Cumberland County Subdivision and Land Development Review Report

Municipality:	<u>Upper Allen</u>	Surveyor/ Engineer:	<u>Alpha Consulting Engineers, Inc.</u>	Owner/ Developer:	<u>Highview Commercial</u>
Plat Title:	<u>151 Gettysburg Pike</u>				
Plat Status:	<u>Preliminary/Final</u>	Plat Type:	<u>Subdivision and Land Development</u>		
# of New Lots:	<u>1</u>	# of New Dwelling Units:	<u>0</u>	New Acreage Subdivided/Developed:	<u>2.93</u>
				Total Tract Acreage:	<u>2.93</u>
Zoning District:	<u>C-2</u>	Proposed Land Use:	<u>Convenience Store/Restaurant</u>		
Date Received:	<u>6/1/2020</u>	County Review:	<u>6/12/2020</u>	Reviewed by:	<u>EG</u>
				Checked by:	<u>SJW</u>

PRELIMINARY / FINAL SUBDIVISION AND LAND DEVELOPMENT PLAN

151 GETTYSBURG PIKE UPPER ALLEN TOWNSHIP CUMBERLAND COUNTY, PENNSYLVANIA

SITE PLAN
FOR
PRELIMINARY / FINAL SUBDIVISION AND LAND DEVELOPMENT PLAN
FOR
151 GETTYSBURG PIKE
UPPER ALLEN TOWNSHIP, CUMBERLAND COUNTY, PENNSYLVANIA

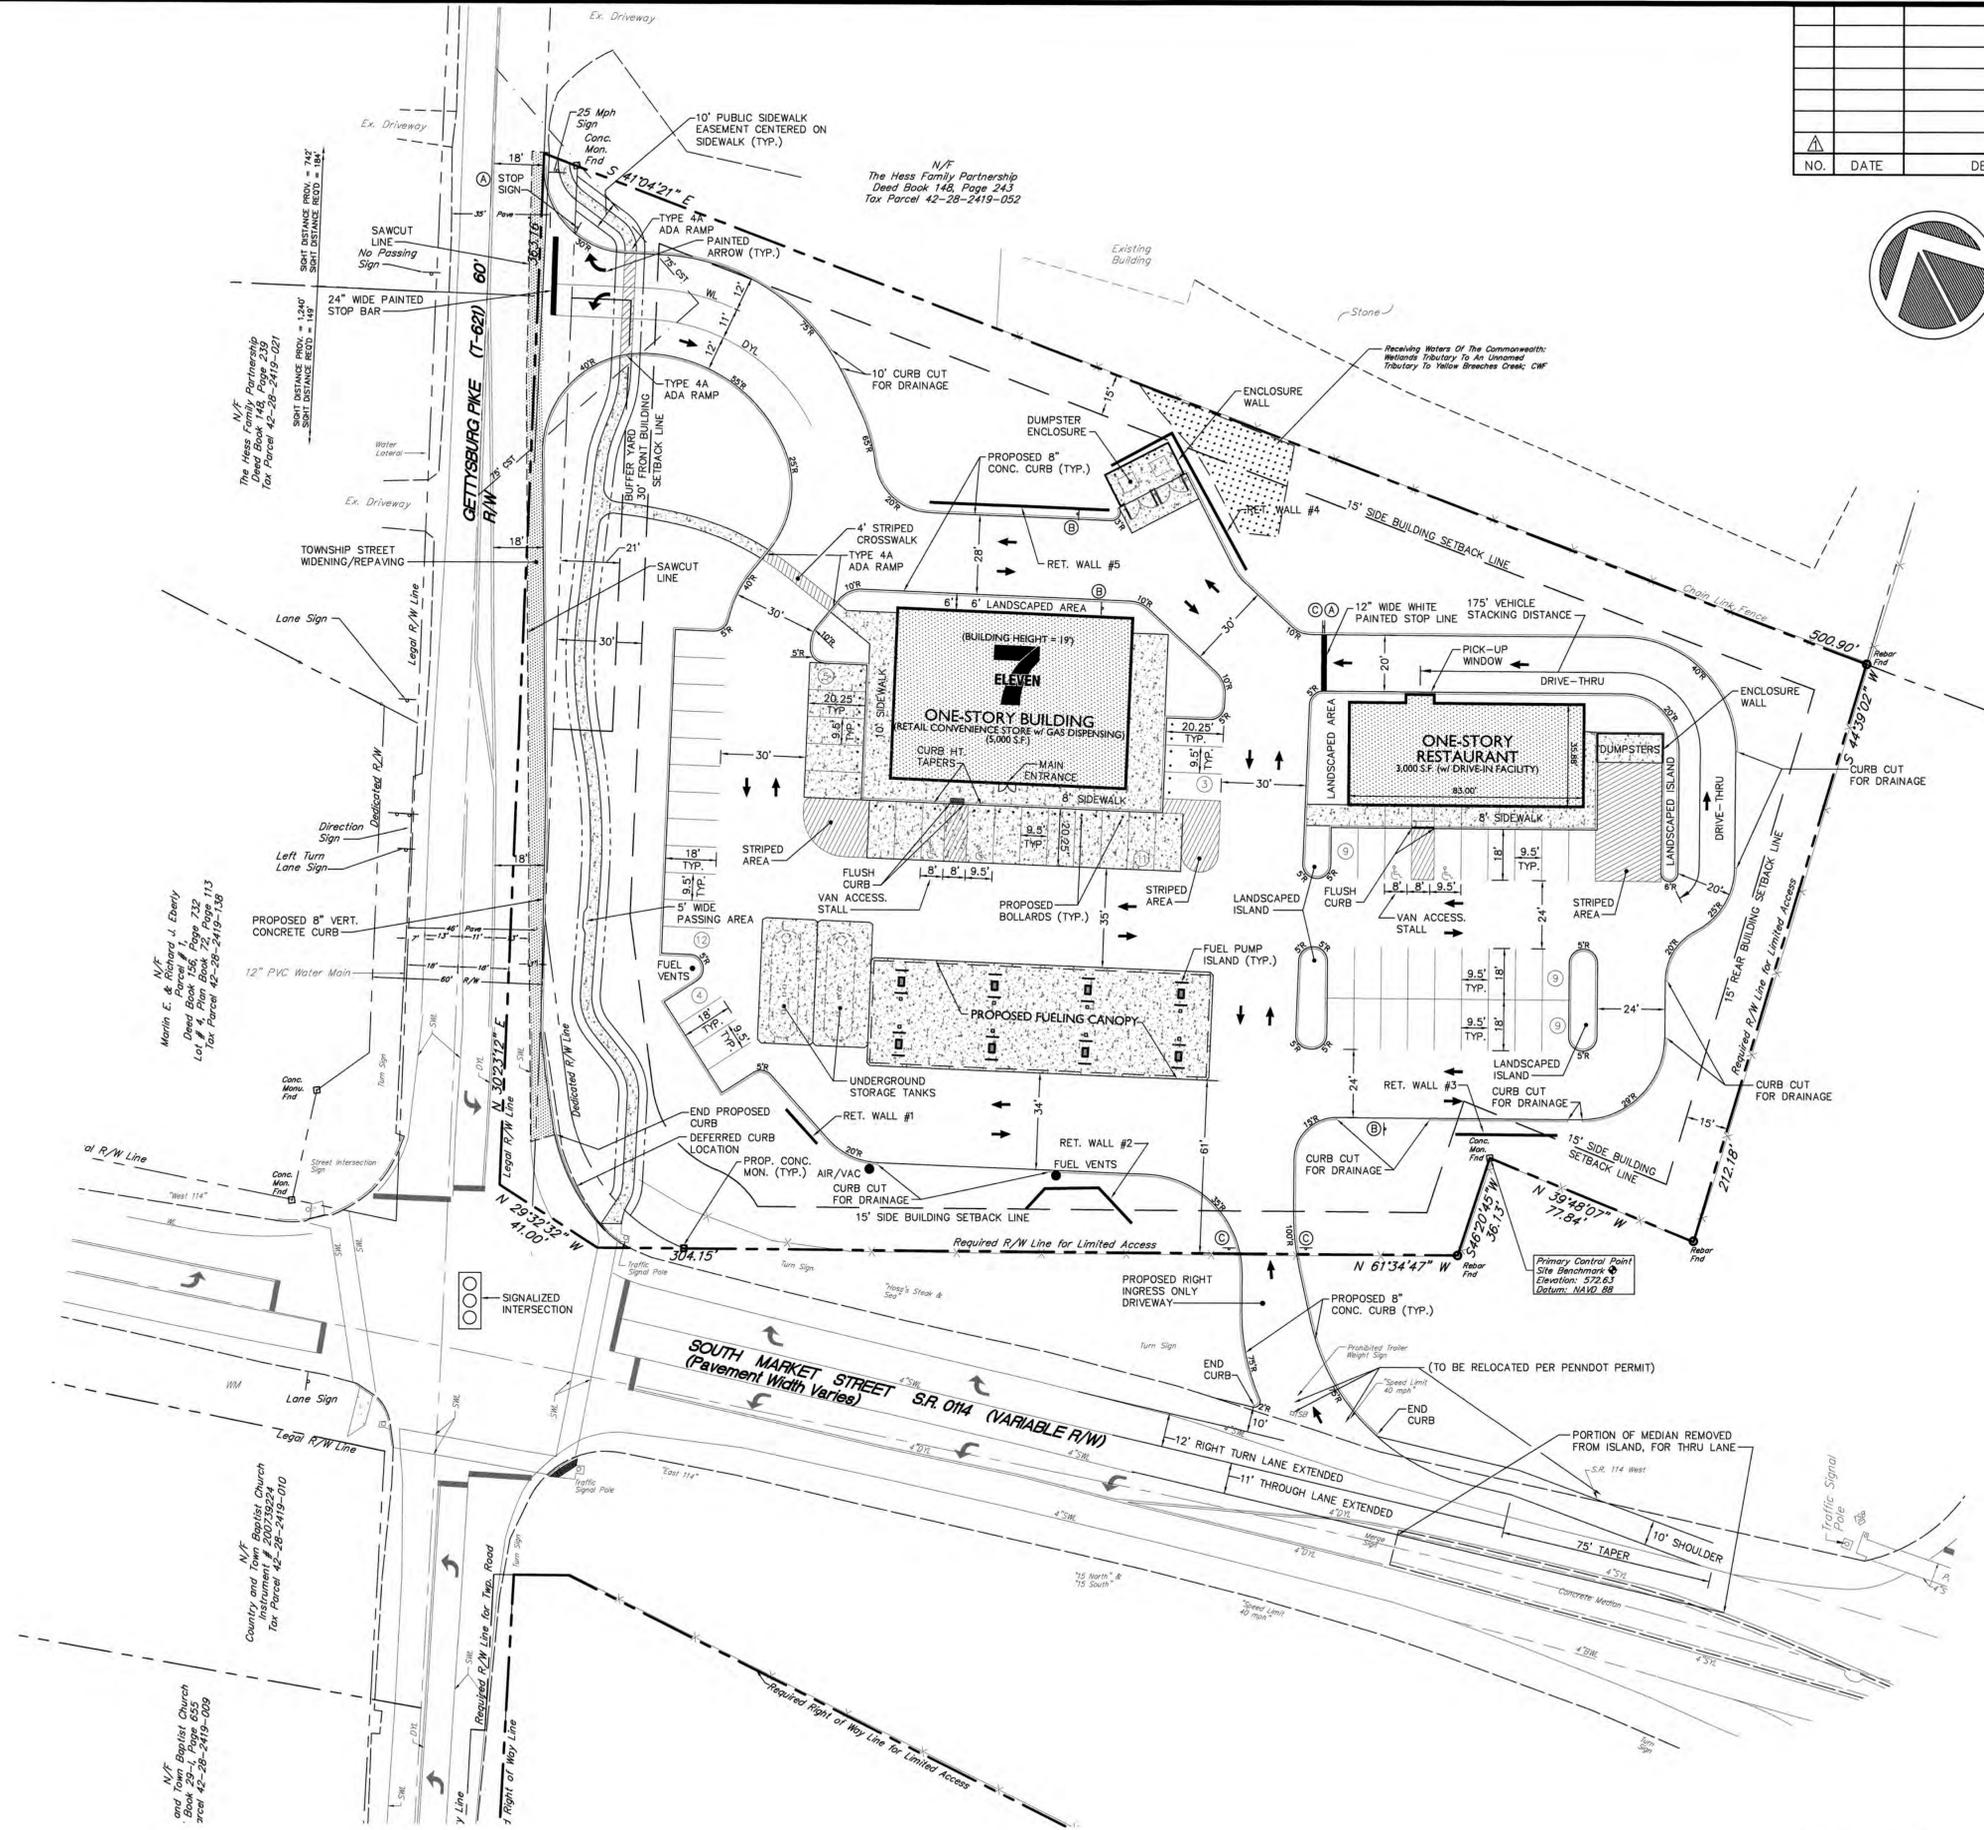
- Calculations for parking provided in Site Data #14 should be verified for the convenience store use. It appears that 1 space per 200 feet of retail area is required. (Zoning 245-17.2.A)

- The width of the access drive off Gettysburg Pike should be reviewed, as it appears to have 3 travel lanes, with a required width of 12 feet each. (Zoning 245-17.6.C.4)

- A traffic study should be submitted with the plan to analyze internal circulation patterns as well as impacts on nearby roads. The Township should verify that information related to parking has been provided as part of the required traffic study (Zoning 245-14.19.L and 245-17.2.D)
